# ADA Curb Ramp New Construction Inspection Form (Combination)

NW Curtis

23885.56

NW Pacific

COMBINATION RAMP (C)

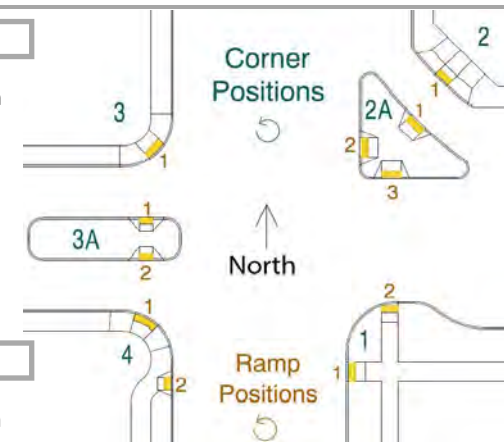
Ramp run 2, Ramp run 3, clear width less than 3ft
